ARLINGTON AVENUE BRIDGES REPLACEMENT

Design Review Committee Meeting #6 | September 13, 2022

South Bridge

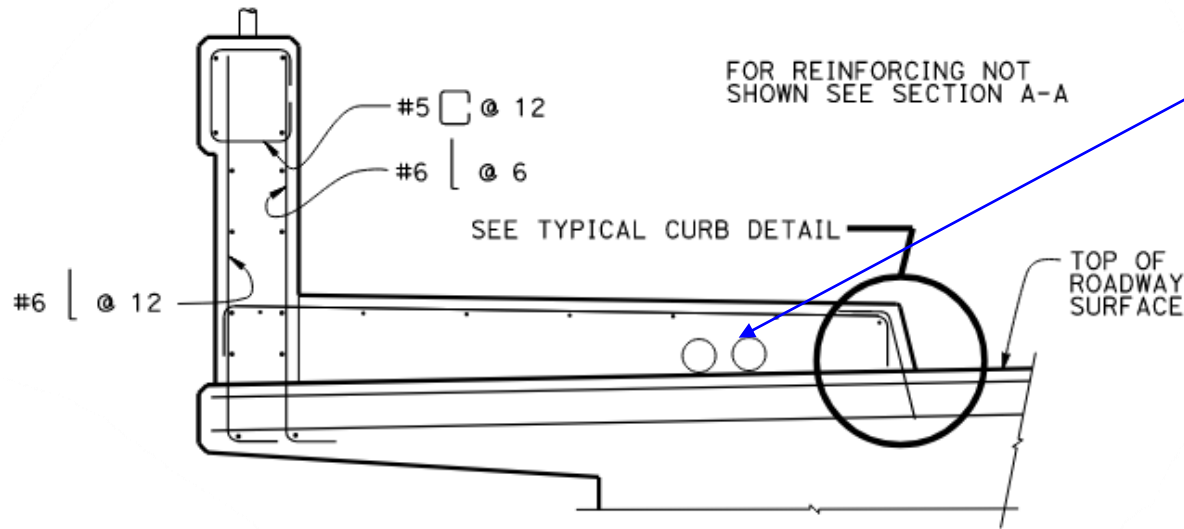
- Underground the existing Overhead
- Pole - P1004811 at end of Elsie Ave.

Potential Utility Routing Detail

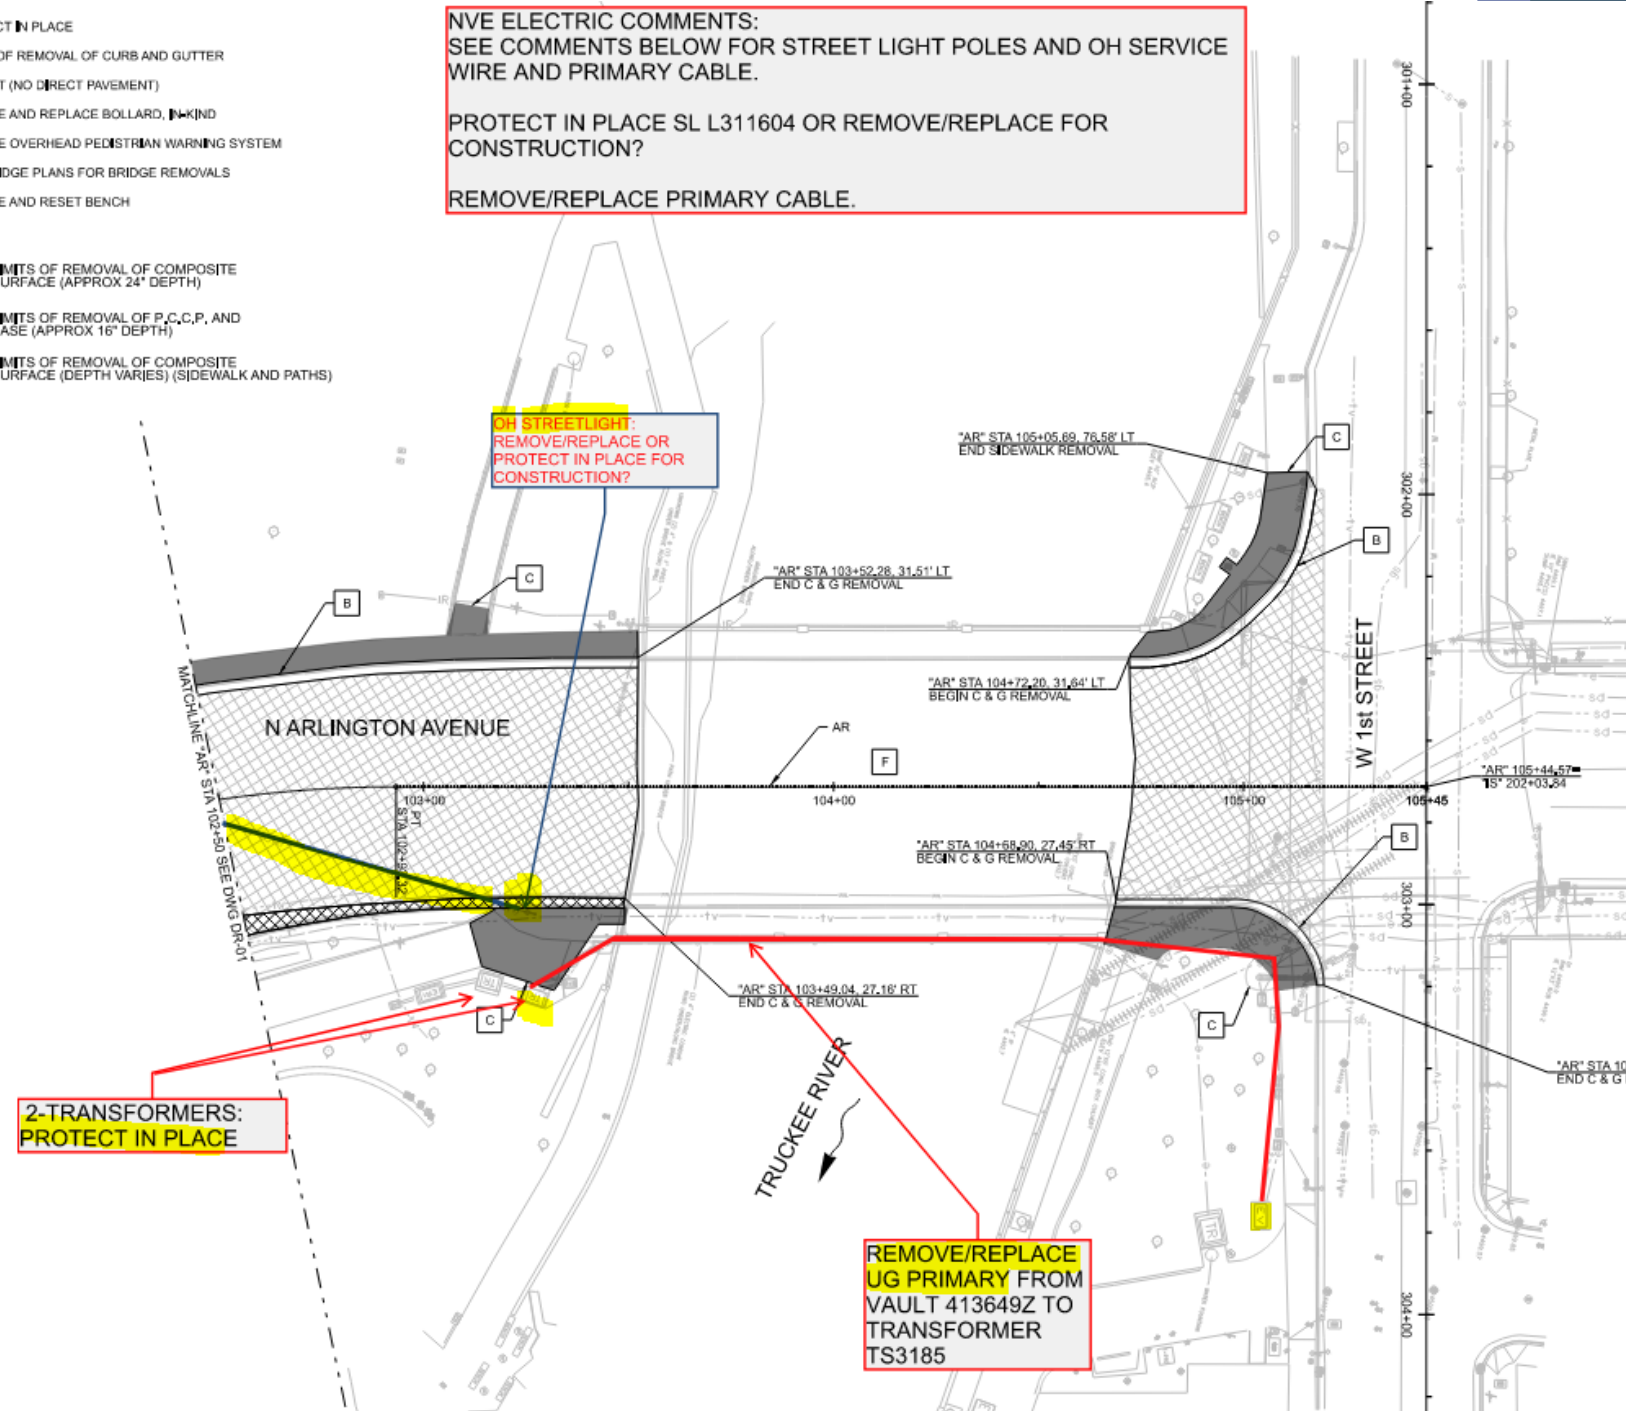
- NV Energy has discontinued the installation of decorative streetlights; only install standard cobra head
- Install meter pedestal; City can serve any type of streetlight from there
- To underground - Customer to open new NVE project and cover cost
- Across Bridges - What can be accommodated? 5 - 4" and 3 - 3" ? (8 total)

Up to 7-4" Conduits
can be run on each
side of the bridge
(between curb and
barrier face)

14 Total 4" Conduits

North Bridge

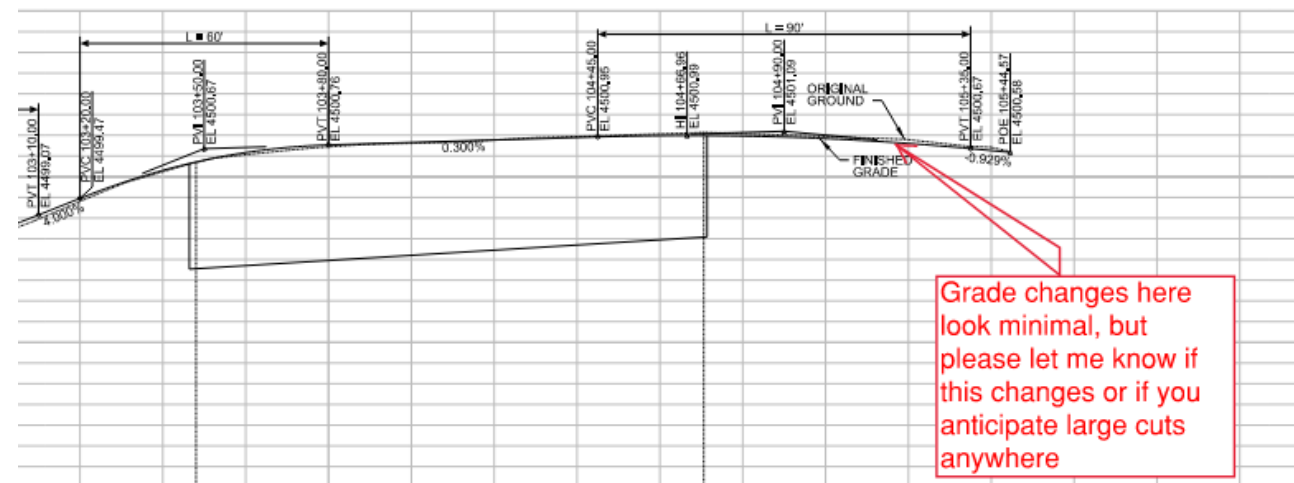
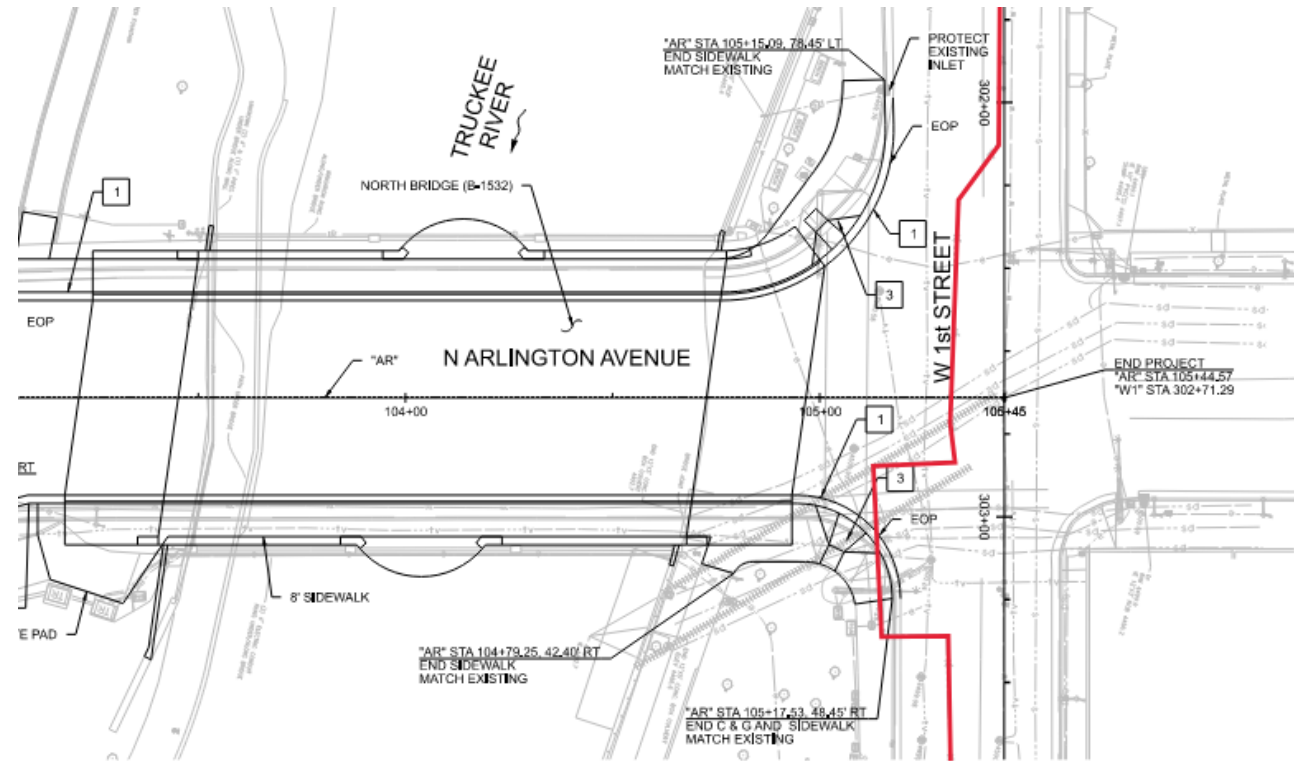
- Underground the OH-E
- Remove/Replace UG Primary from Vault to Transformer Through New Bridge (2-4" Conduits)
- Streetlights and Services in this area directly serve the customer - Apply for Formal Electrical Project: inforeno@nvenergy.com

NVE ELECTRIC COMMENTS:
SEE COMMENTS BELOW FOR STREET LIGHT POLES AND OH SERVICE WIRE AND PRIMARY CABLE.
PROTECT IN PLACE SL L311604 OR REMOVE/REPLACE FOR CONSTRUCTION?
REMOVE/REPLACE PRIMARY CABLE.

NVE - GAS

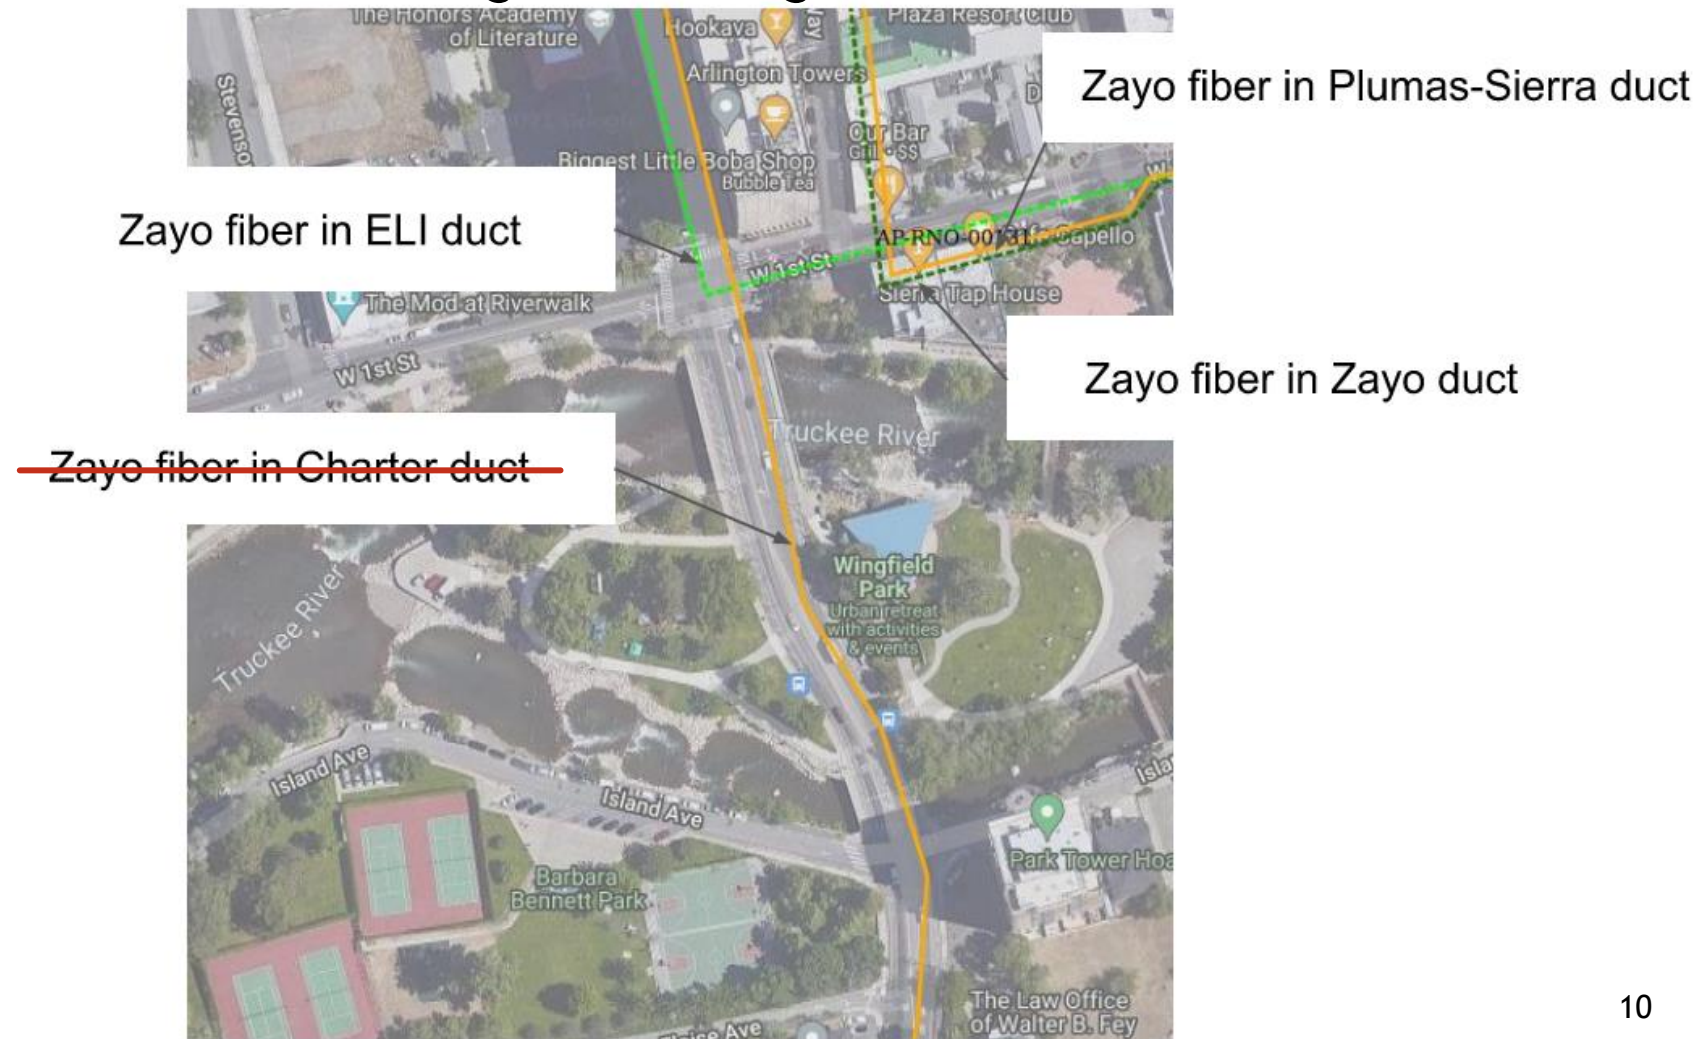
Grade changes here look minimal, but please let me know if this changes or if you anticipate large cuts anywhere

SE Corner Storm Drain

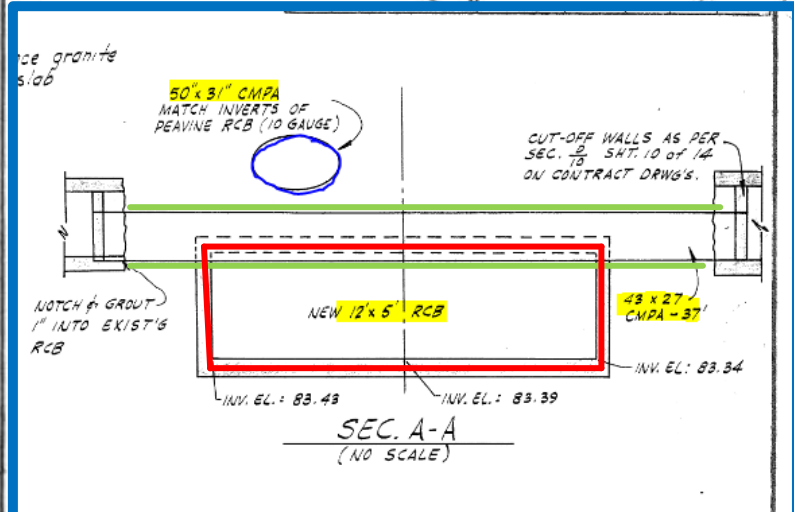
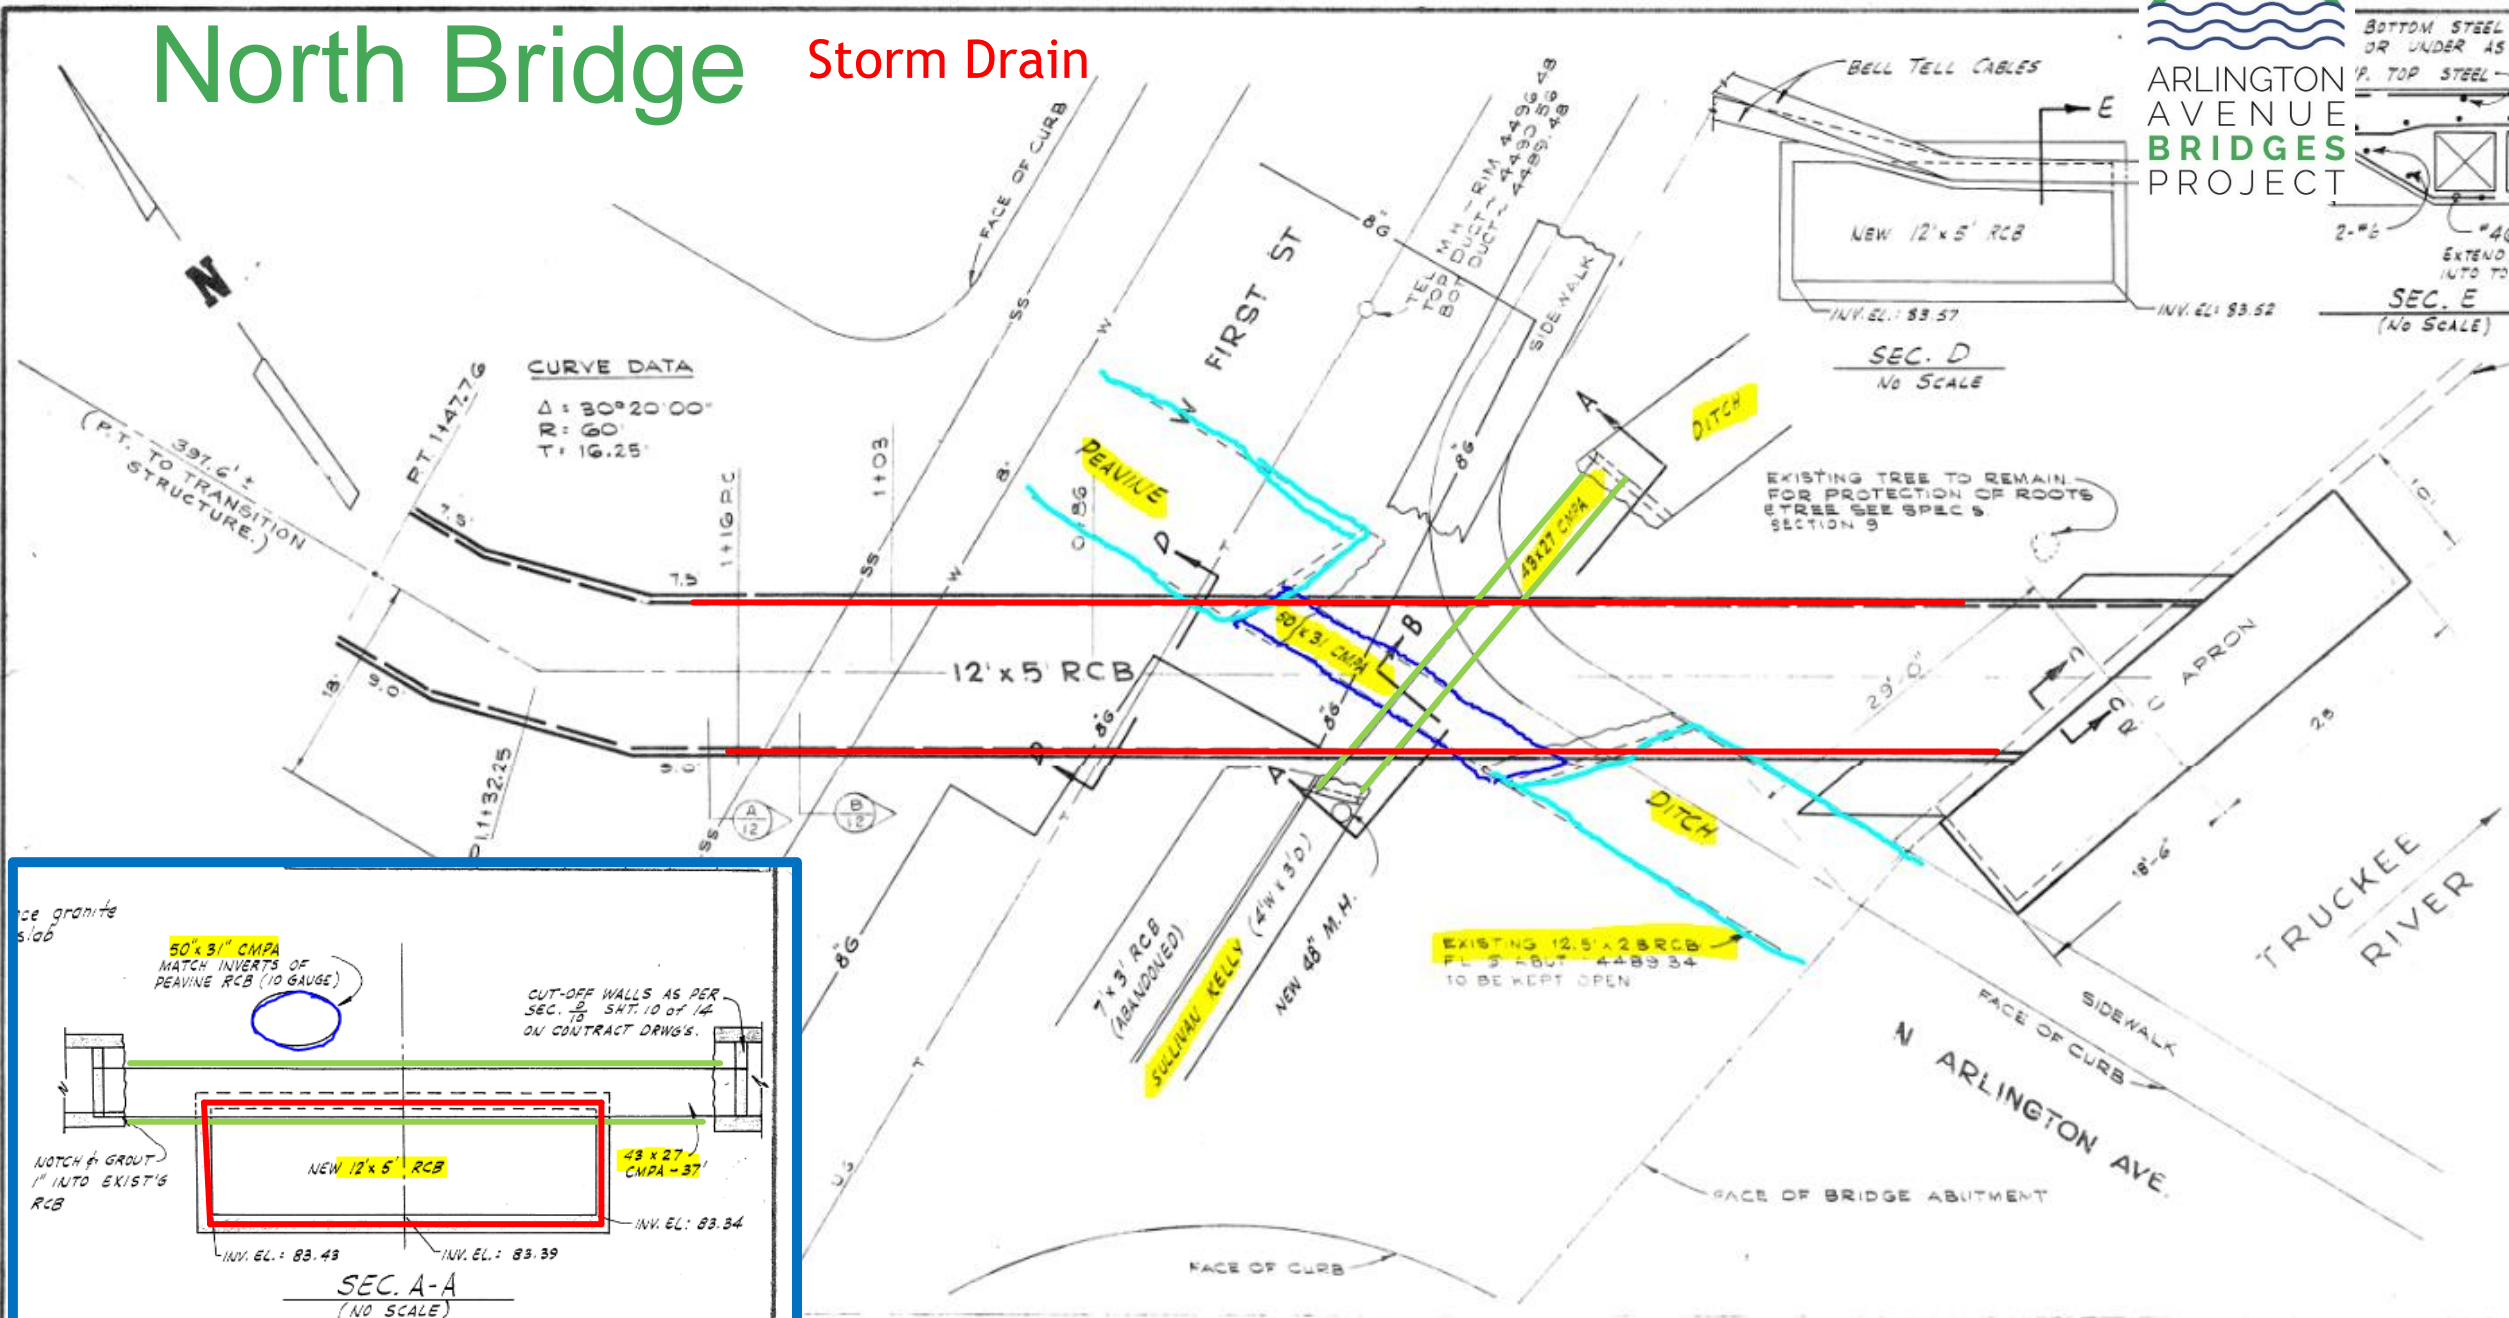
Confirm SD Size - 42" or 36"
